**CAMINO DE LAS PALMAS FINAL FOUNDATION REPORT**

**FINAL FOUNDATION REPORT  
CAMINO DE LAS PALMAS  
RETAINING WALL  
STATE ROUTE 125  
KP 19.47 TO 22.37  
SAN DIEGO COUNTY, CALIFORNIA  
CALTRANS FILE NO. 11-SD-125  
CU 1120 E.A. 253501**

Subject: Camino De Las Palmas Retaining Wall- Foundation Report

Subject: Camino De Las Palmas Retaining Wall- Settlement Analysis

# SECTION B-B'

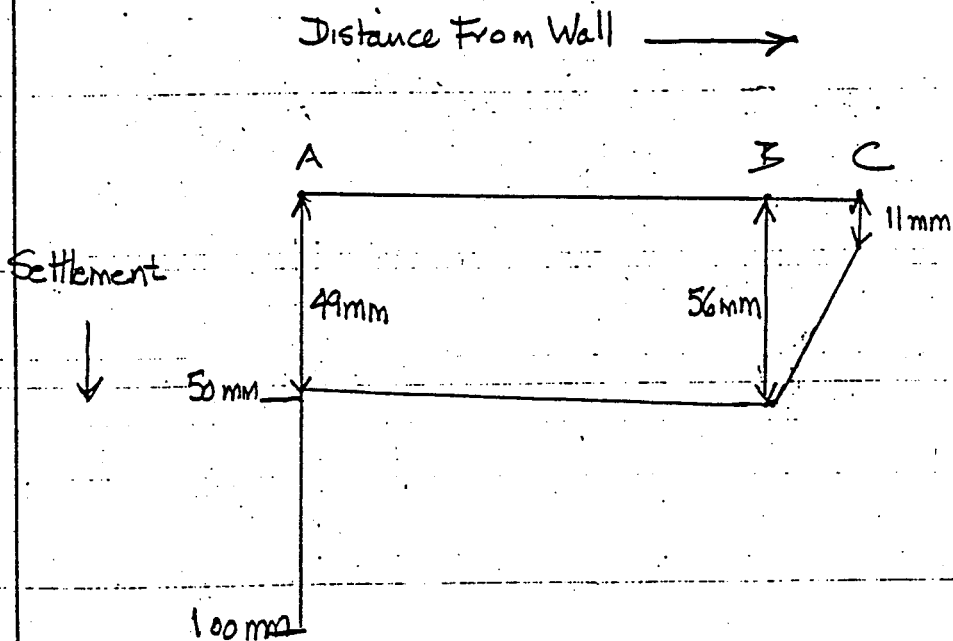
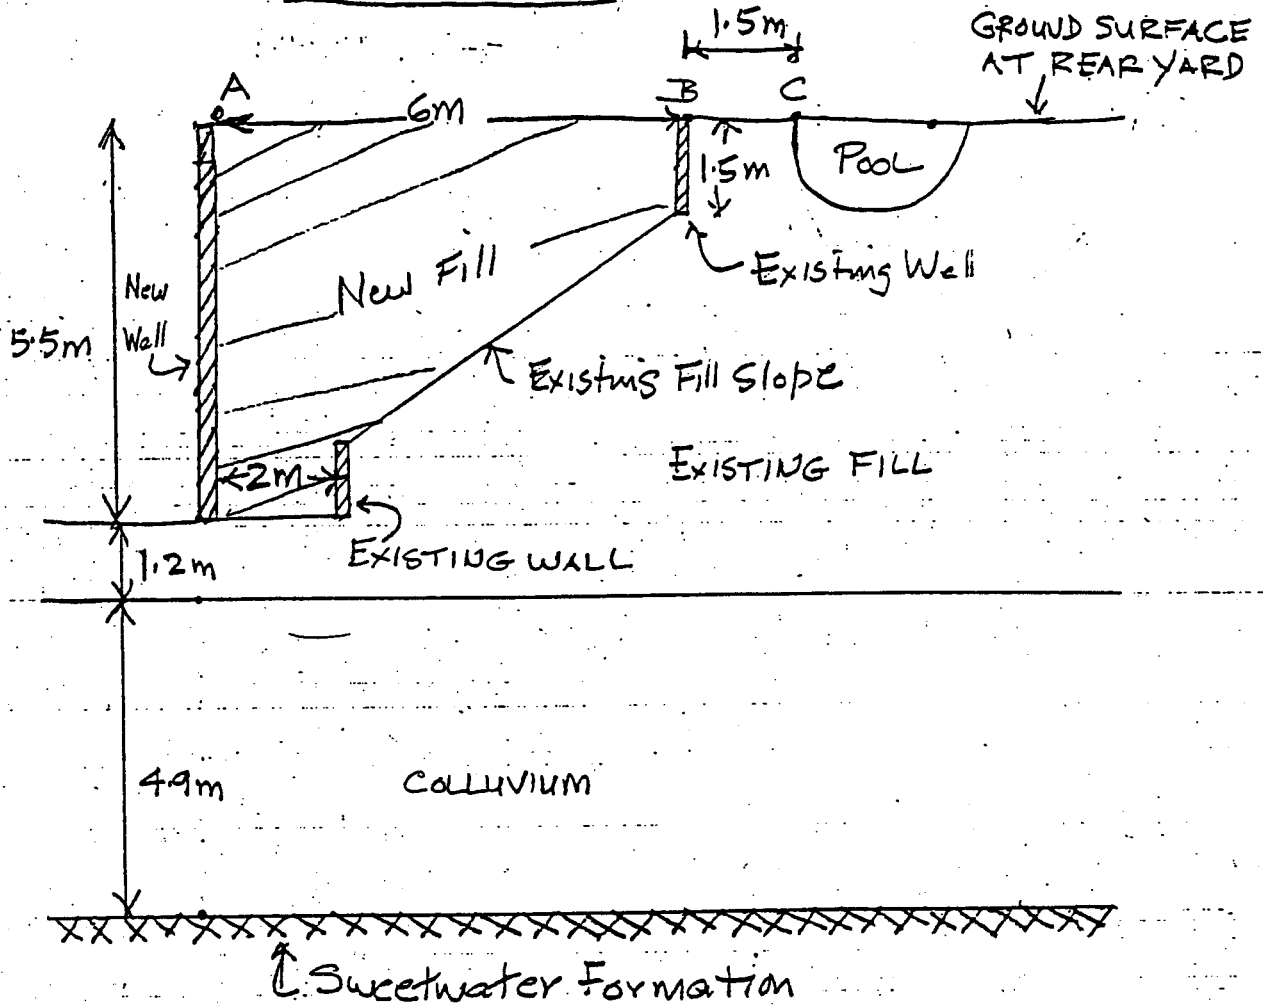
Settlement estimates have been prepared for the loading configurations and soil profiles shown for cross-sections A-A', B-B' and C-C', respectively. These estimates are based on consolidation test data for fill and colluvium that were presented by Ninyo and Moore in their geotechnical engineering reports for the project. The results of our settlement estimates are presented in the figures that are attached to this report. Estimated total settlements for cross-section A-A' range from 25 to 35mm along the two edges of the new fill and 7mm at a point 1.5m beyond the edge of the new fill immediately adjoining the rear yard. For section B-B' estimated total settlements range from 49 to 56mm along the two edges of the new fill and 11mm at a point 1.5m beyond the edge of the new fill immediately adjoining the rear yard. For section C-C' estimated total settlements range from 19 to 42mm along the two edges of the new fill and 7mm at a point 1.5m beyond the edge of the new fill immediately adjacent to the rear yard.. Settlements are estimated to be very low to negligible from a distance of 1.5m to 3m beyond the edge of the new fill immediately adjacent to the rear yard. No settlements are expected to occur at the residential structures which are about 6 to 9m away from the edge of the proposed new fill. Additionally, it is anticipated that the estimated settlements will occur rapidly and that settlements will stabilize within 90 days on completion of fill placement.

Based on the above estimates, it can be concluded that settlements from the new fill loads will vary from about 25 to 56mm (1 to 2 inches). While these settlements are not deemed to be inordinately high, distress to patio slabs, pool decks, planter walls and other exterior improvements within 1.5 to 3m of the edge of the new fill may possibly occur from the 7 to 11mm of estimated settlements. Based on our analysis it is our opinion that the nearby residential structures should not undergo any new settlement as a result of the construction of the wall.

We recommend that floor level surveys of the interiors of the residential structures be performed prior to and three months after completion of the wall backfilling operations. This should be done in order to establish whether any alleged distress could be attributed to construction of the retaining wall. Additionally, we recommend that survey points be established at random locations in the rear yards and also the residential structures to monitor any potential movements as a result of the construction.
